The University of Sydney Health Precinct Stage 1 Project

BCA 2016 – SD Stage Final Assessment under BCA2016

Report Ref: 17-208224_PChun_UoS Health Precinct_Concept Dev_Final_20180119

DESCRIPTION
 AREA PLAN - LEVEL 0

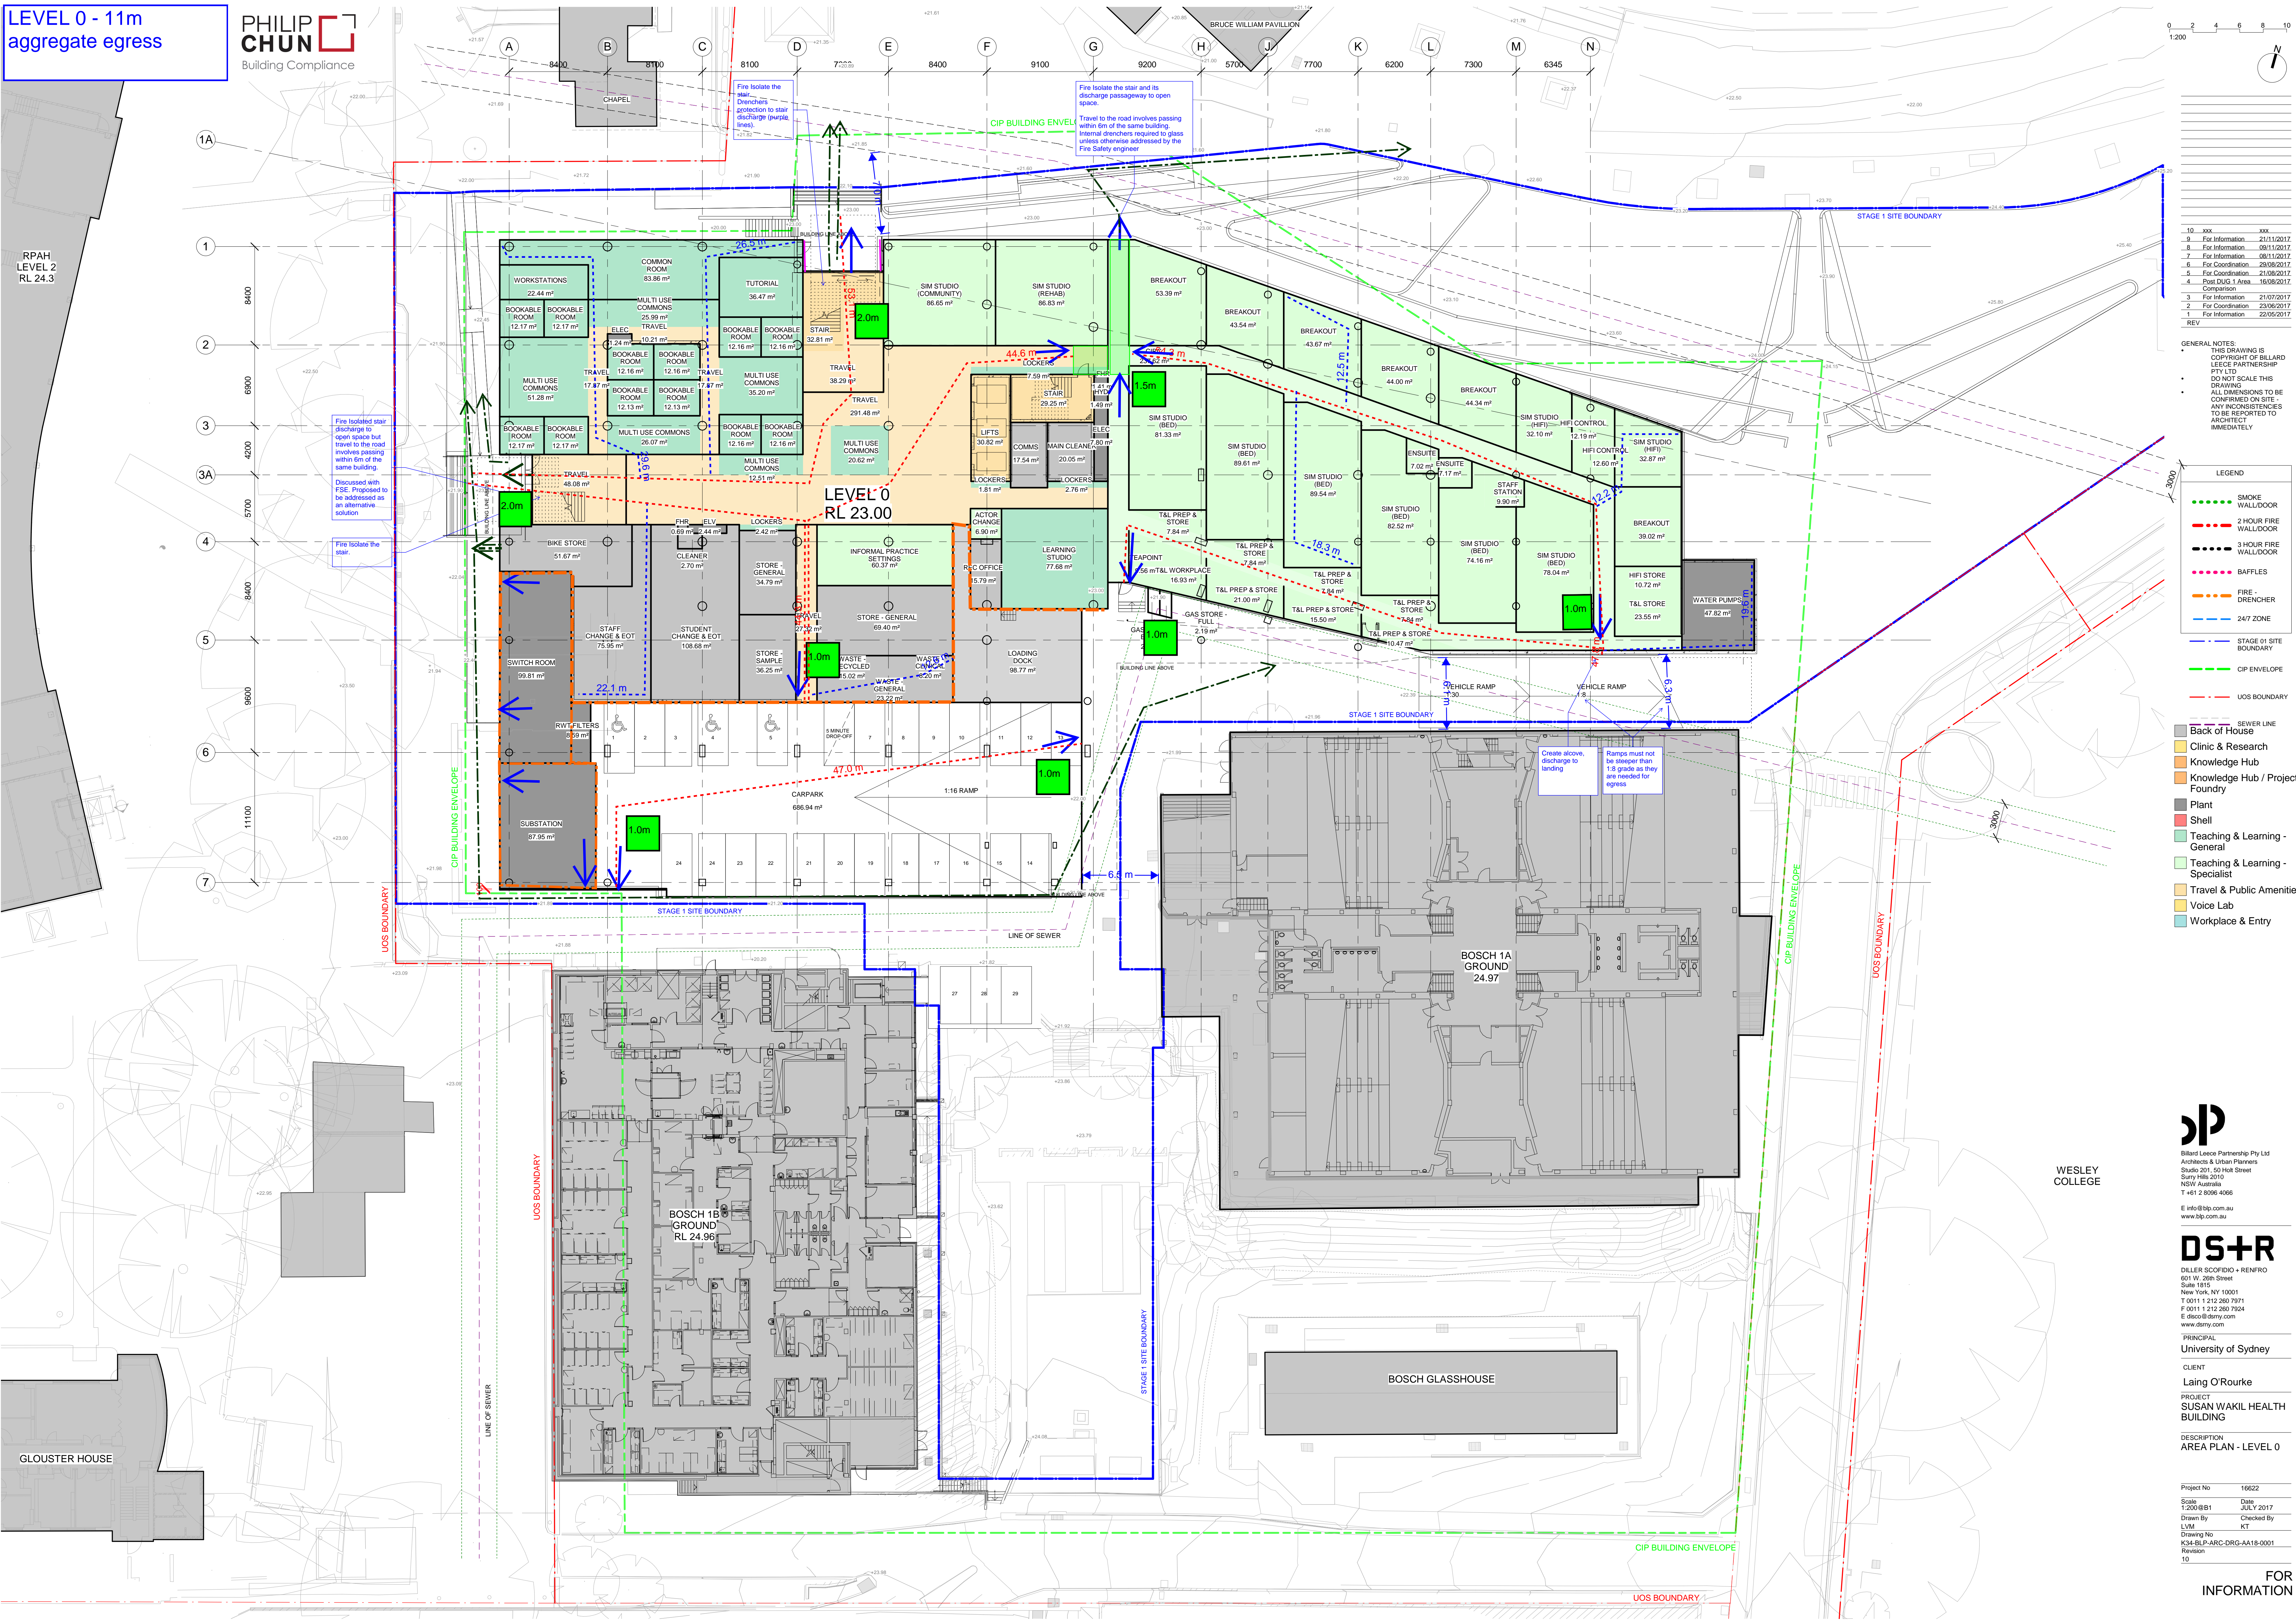
LEVEL 0 - 11m aggregate egress

DESCRIPTION
AREA PLAN - LEVEL 1

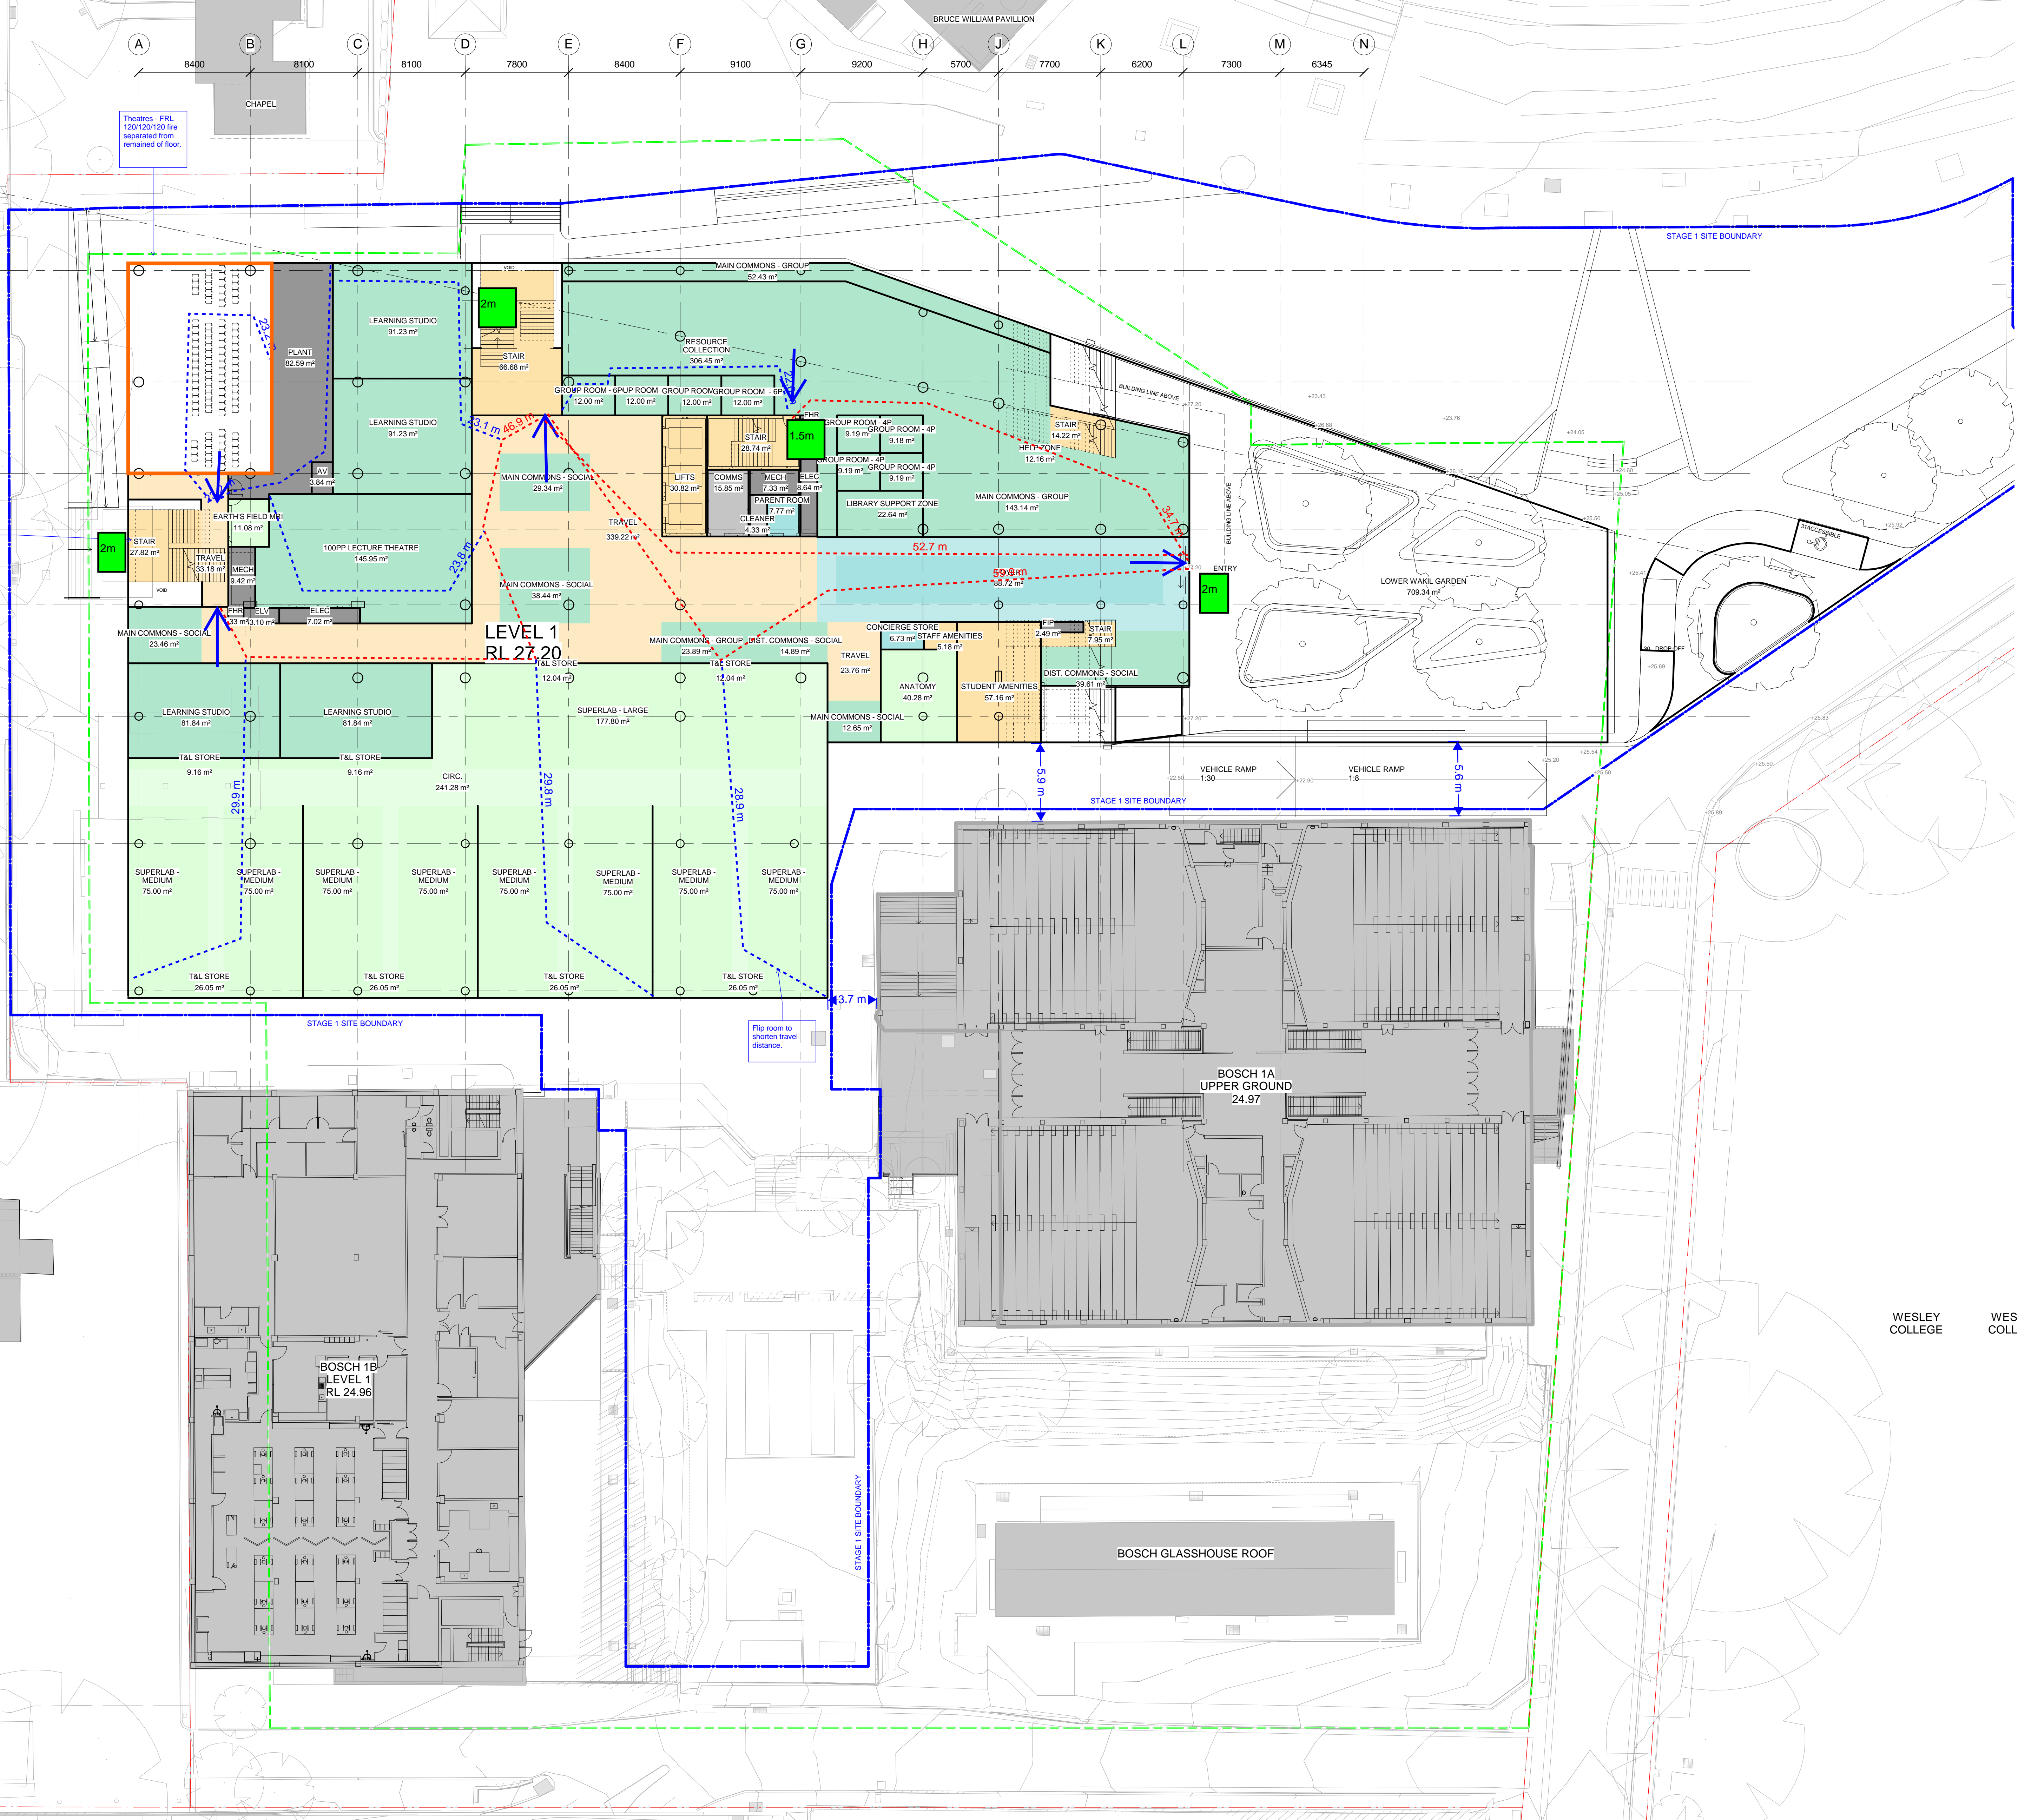
LEVEL 1 - 7.5m
aggregate egress

DESCRIPTION
 AREA PLAN - LEVEL 2
 Project No 16622
 Scale 1:200/BB1 Date JULY 2017
 Drawn By LVM Checked By KT
 Drawing No K34-BLP-ARC-DRG-AA18-0201
 Revision 10

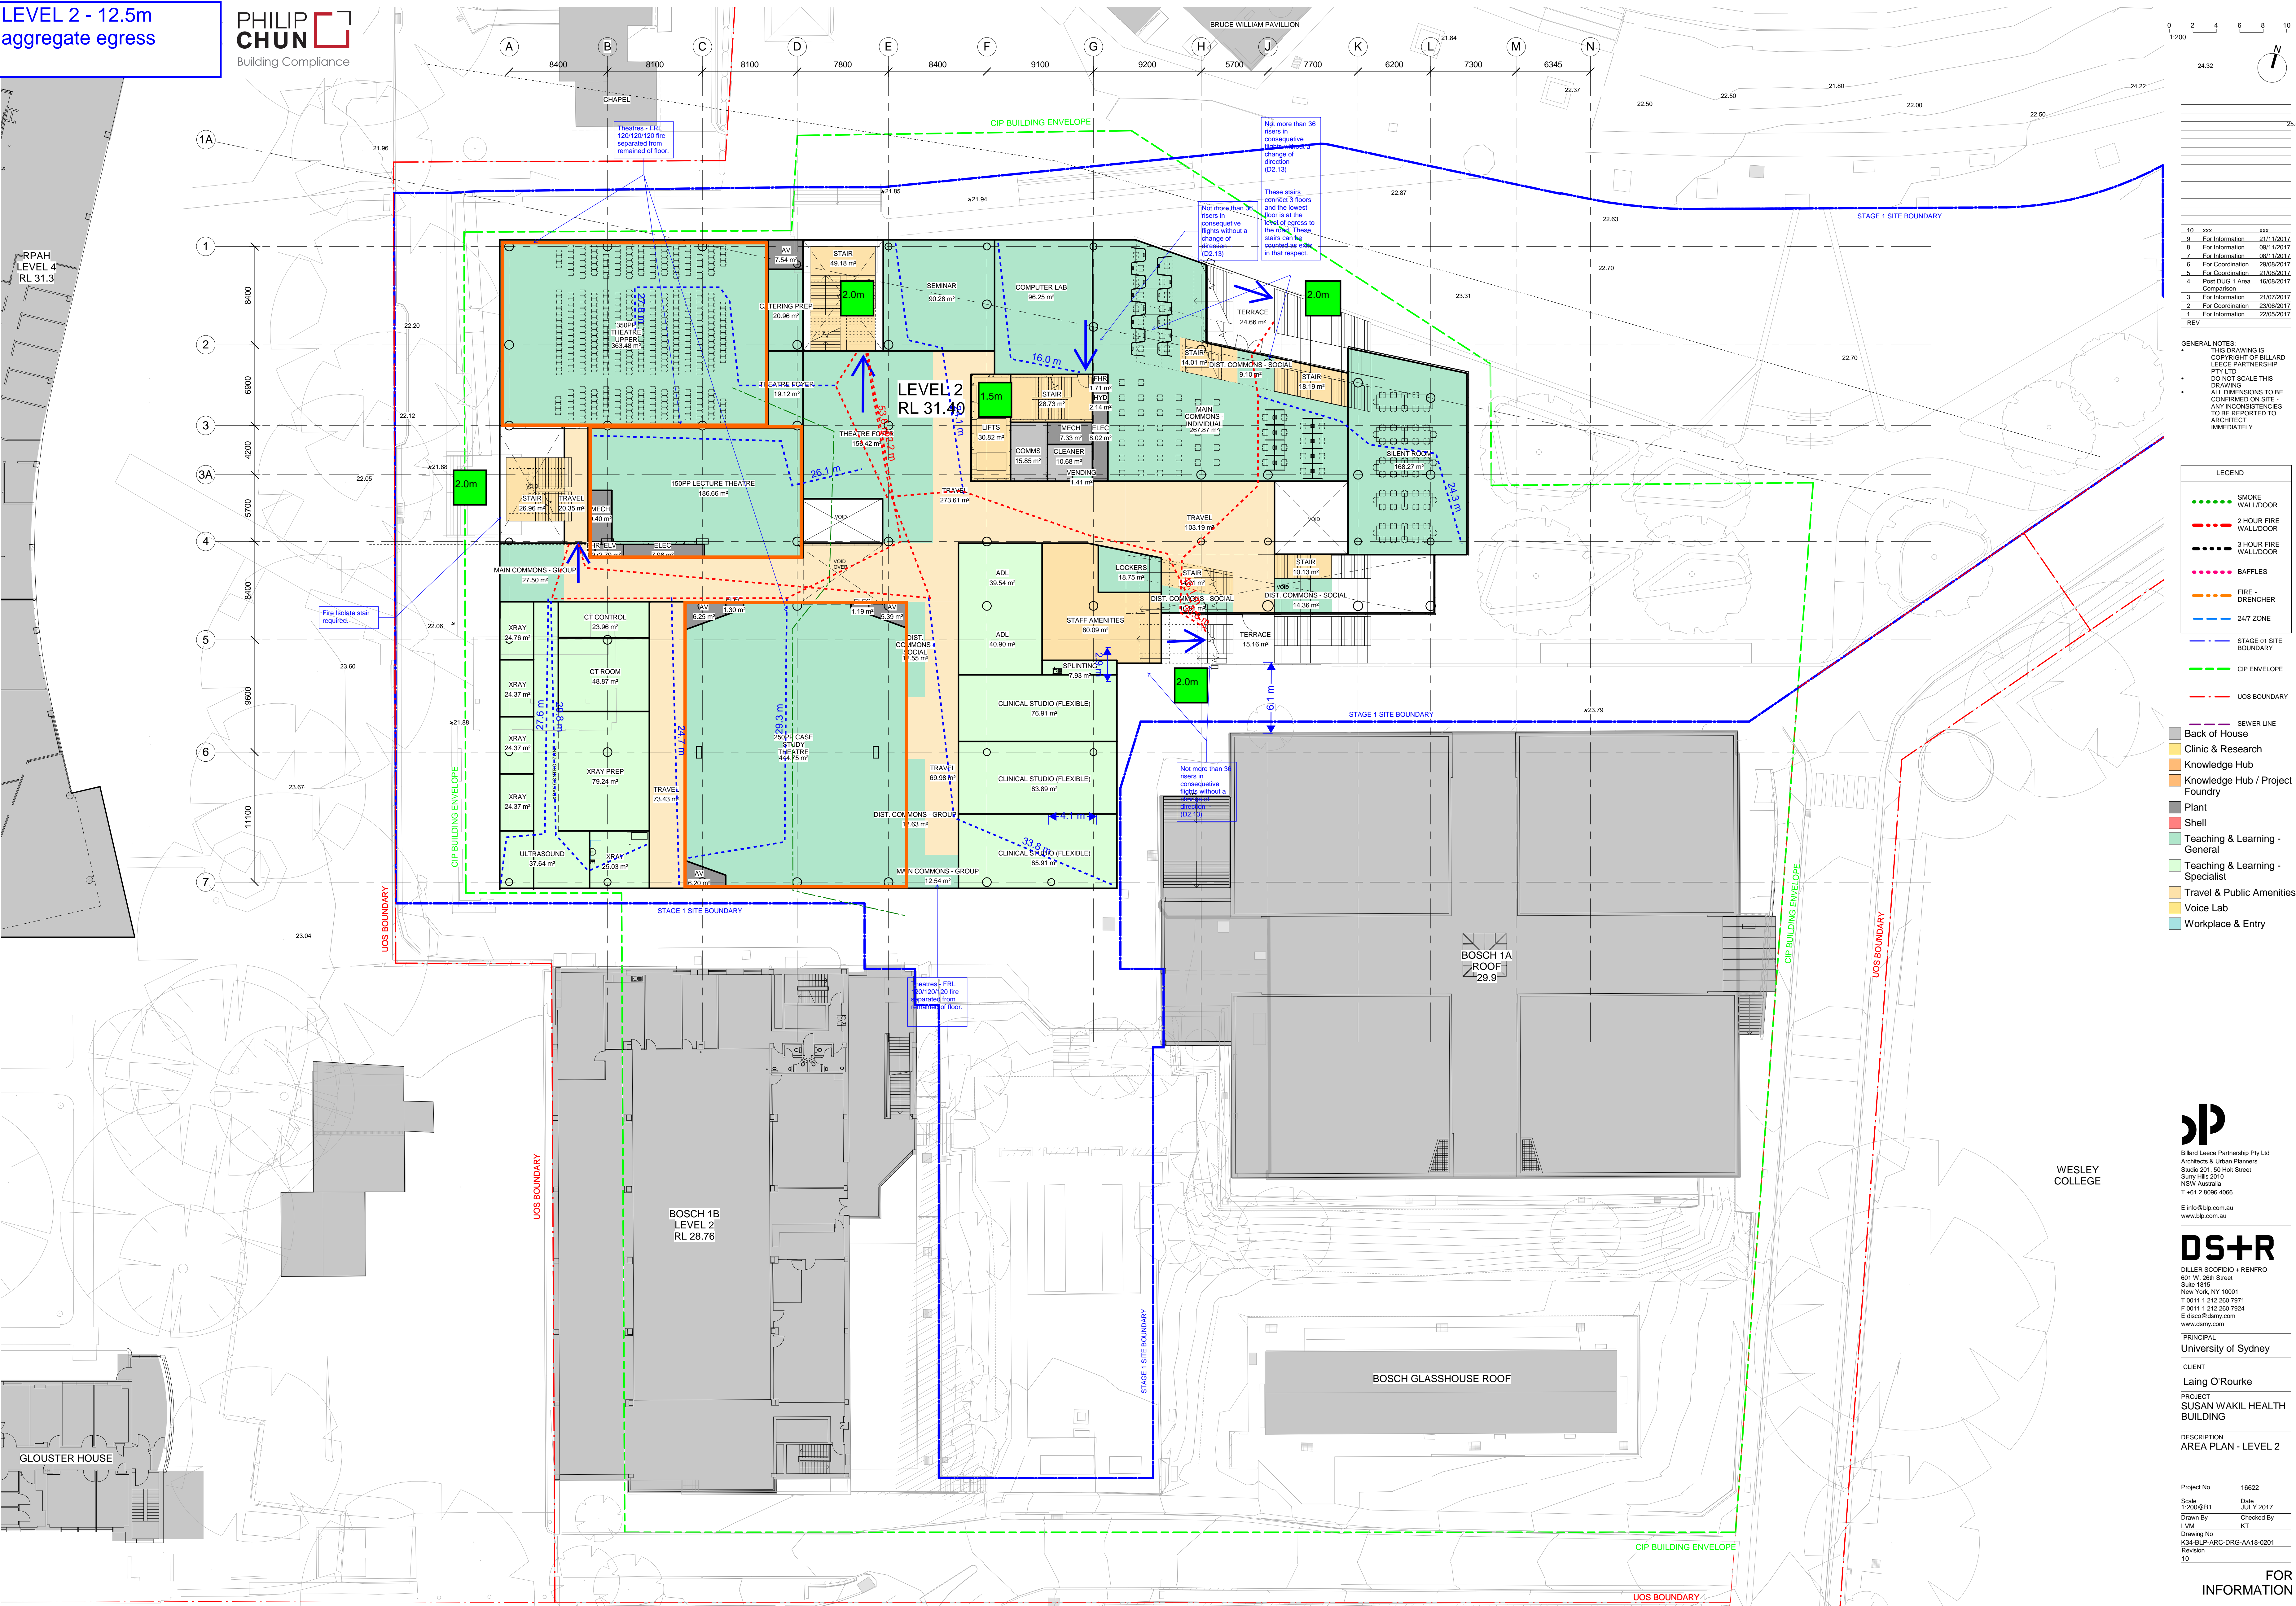
LEVEL 2 - 12.5m aggregate egress
